Work Order ID 132277

Item Name: Aft Crosstube - High 407

Reference: REWORK PER ECN 15-557

ECN 15-557

**D407-667-245
ASSEMBLY DETAIL
(VIEW LOOKING FWD)**

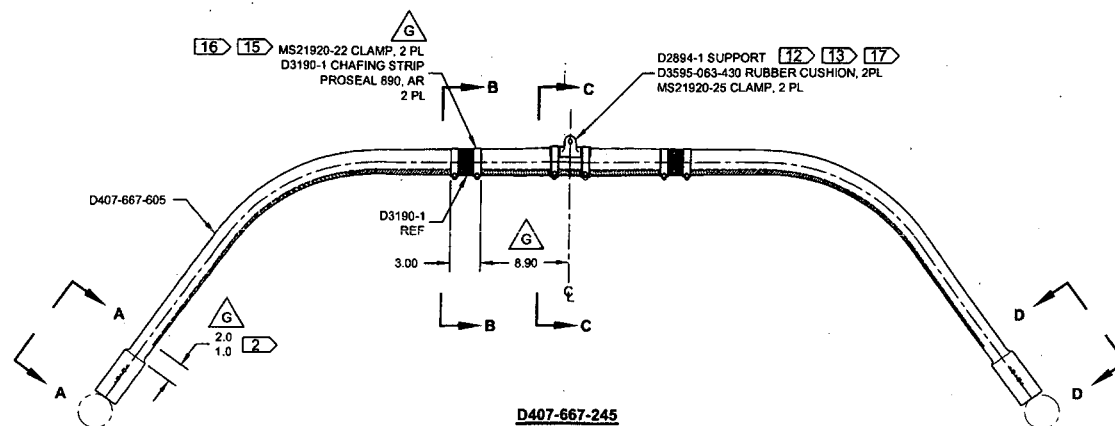
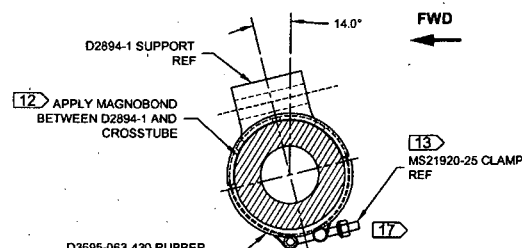
G	INCRP. DEO's D407-667-245-F1/F2 (ZN D8-1, A8-1, D5-2, B6-2, C6-2); 8.90 WAS 8.53 (ZN D5-2); TORQUE REDUCED FOR CHAFING SHIELD (ZN A6-1); FINISH REVISED TO ALLOW MANUFAC. FLEXIBILITY (ZN C8-1)	RF	15.03.20
F	REFORMAT NOTES TO NEW STANDARDS (ZN B8-1); RELOCATED FLAG # 6 (ZN A8-3) PER NCR 210; REMOVED REF. & ADD TOLERANCES (ZN C6-3, C4-3 & D2-3)	RF	08.11.06
E	8.02 AND 8.53 WERE 8.40 AND 8.90 (ZN D5-2); REORGANIZED VIEWS AND REFORMATED DRAWING TO CURRENT STANDARDS. REASONS: CLAMPS MOVED 0.375 TOWARD CL TO ELIMINATE INTERFERENCE WITH AIRCRAFT MOUNTS. REFERENCE: PAR#08-21 AND ECN#1225	MB	08.07.24
D	ADD VIEW FOR OEM SKID HOLES, ROTATE ORIENTATION OF CLAMPS SECTION F-F, REMOVE -851 ABRASION STRIP, ADD MAGNOBOND 6398, ADD CUSHION	PH	07.02.07
C	ADD HOLES AND NUT PLATES FOR COMPATIBILITY WITH BHT/AA SKIDTUBES	PH	05.07.26
B	ADD CHAFING SHIELD	CP	03.05.21
A	NEW ISSUE	CP	02.05.13
REV.	DESCRIPTION	BY	DATE
DESIGN	RF	DART AEROSPACE LTD HAWKESBURY, ONTARIO, CANADA DRAWING NO. REV. G D407-667-245 SHEET 1 OF 4 TITLE SCALE CROSSTUBE ASSY (407 HIGH AFT) NTS COPYRIGHT © 2002 BY DART AEROSPACE LTD THIS DOCUMENT IS PRIVATE AND CONFIDENTIAL AND IS SUPPLIED ON THE EXPRESS CONDITION THAT IT IS NOT TO BE USED FOR ANY PURPOSE OR COPIED OR COMMUNICATED TO ANY OTHER PERSON WITHOUT WRITTEN PERMISSION FROM DART AEROSPACE LTD.

NEEDS TO BE REWORKED PER ECN 15-557

REMOVE CHAFFING SHIELDS AND CLAMPS (MS21920-22)

REPLACE WITH NEW PER NEW DRAWING REV G

1- Install chafing shield as per D407-667-245 using DT10096 to establish 8.90

****Ensure chaffing is to be position "overlap" AFT****
